TO: HISTORIC PRESERVATION BOARD

RE: Certificate of Appropriateness 2023-COA-11 Construction of a New Shed at

826 E Washington Avenue (Alternate Key 1759749)

EXHIBIT C: ELEVATIONS OF NEW REVISED PROPOSED SHED

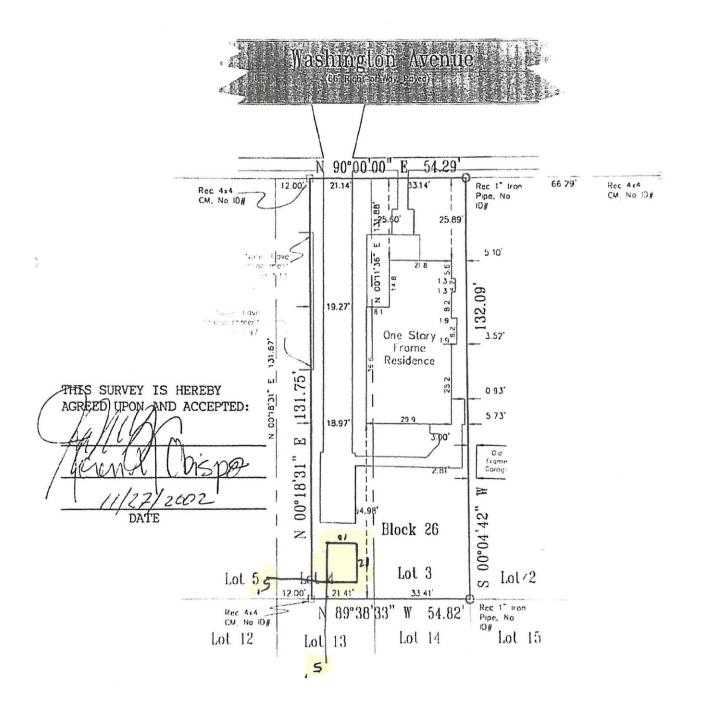
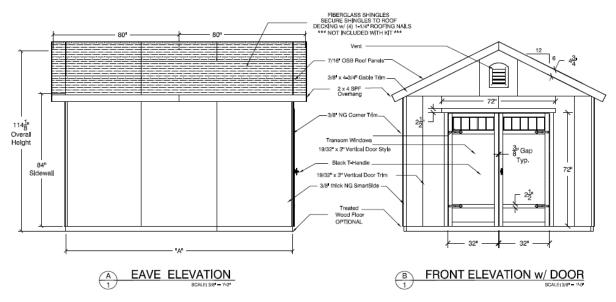
The proposed shed is shown to have features consistent with those of the existing single-family home on the property. The color is not shown on the provided elevations and samples. The shed should be of a matching or significantly similar shade so as to blend. The proposed shed as it faces Washington Avenue does have facing features that would make it more consistent and compatible with the bungalow style.

Peak vent and carriage-style doors with windows are consistent elements of the bungalow style and the existing home.

The proposed color of the shed has not been provided. The "paneling" on the proposed shed is vertical whereas the paneling on the existing home is horizontal, so these two structures will lack some similarities with each other. Overall the elements of the shed are consistent with the bungalow style, i.e..

Low roof pitch, low structural build, gable vent, carriage doors with windows, etc. The color of the shed will need to be consistent with the existing structure.

Color for the proposed shed shall be consistent or compatible with the existing home. The proposed roof pitch is consistent with that of the existing home and the bungalow architectural style.

Based on the analysis above, the criteria for evaluation provided in this memorandum, the revised shed is consistent with the subject property's historic bungalow architectural style and existing development.

Staff recommends approval of this request.
